CITY OF PORTLAND

Permit Number: 080662

Re: Sign Permit Application

Maine Turnpike Authority Headquarters 2360 Congress Street, Portland CBL #233-A004-001 and #233-A008-001

SIGN D-5 - mot whin site

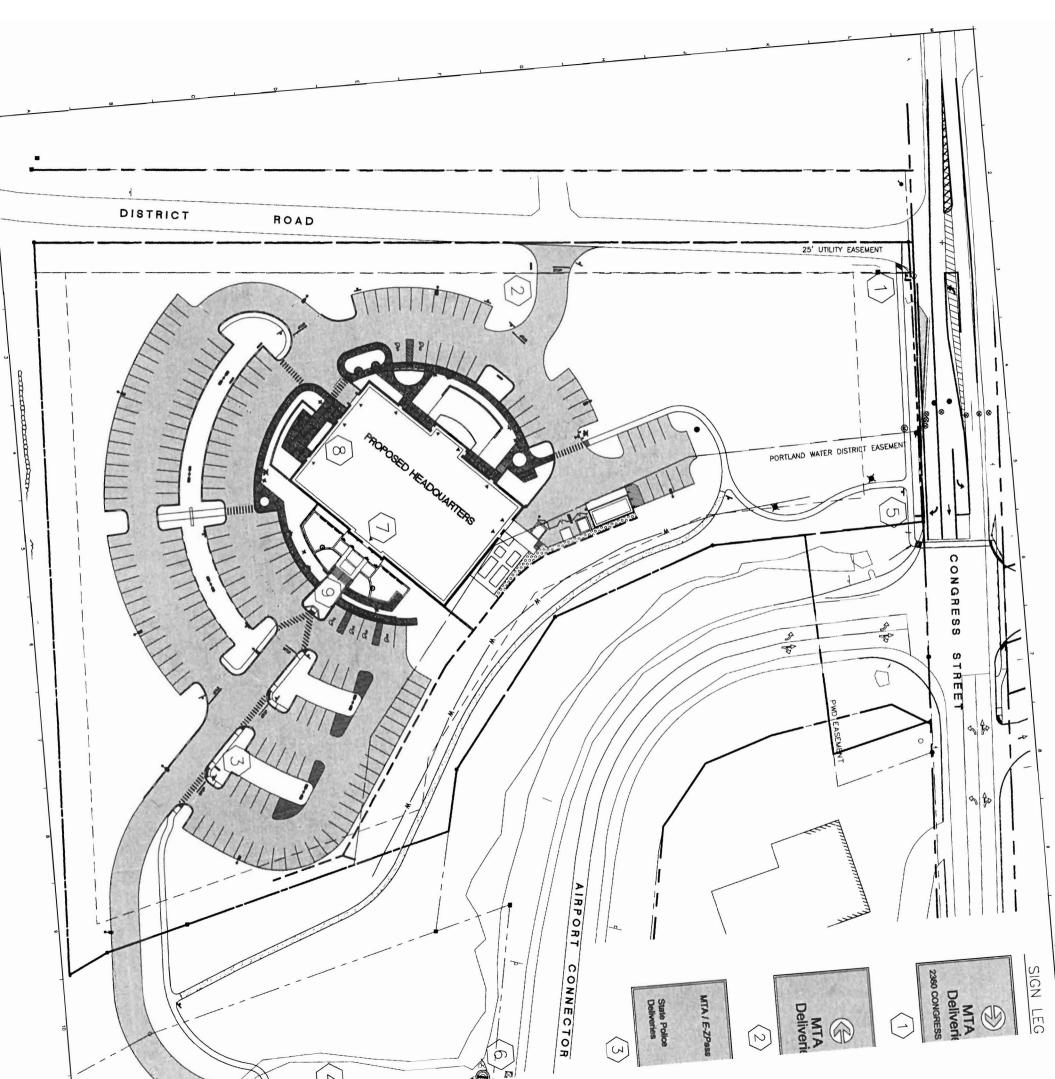
6/23/2008-amachado: Spoke to Mark Johnson. Told him that because of the location, size and infomation on the sign at the corner of Congress & the Airport Connector Road, it is considered a freestanding sign and not a directional or incidential sign, but it meets the ordinance for a freestanding sign. I also told him that the MTA/E-Z Pass plaques on the retaining wall don't meet the zoning ordinance. I am sending the permit to planning for review.

6/23/2008-amachado: Since the sign (D-5) at the corner of Congress and the Airport Connector is not directional, they owe \$40 more.
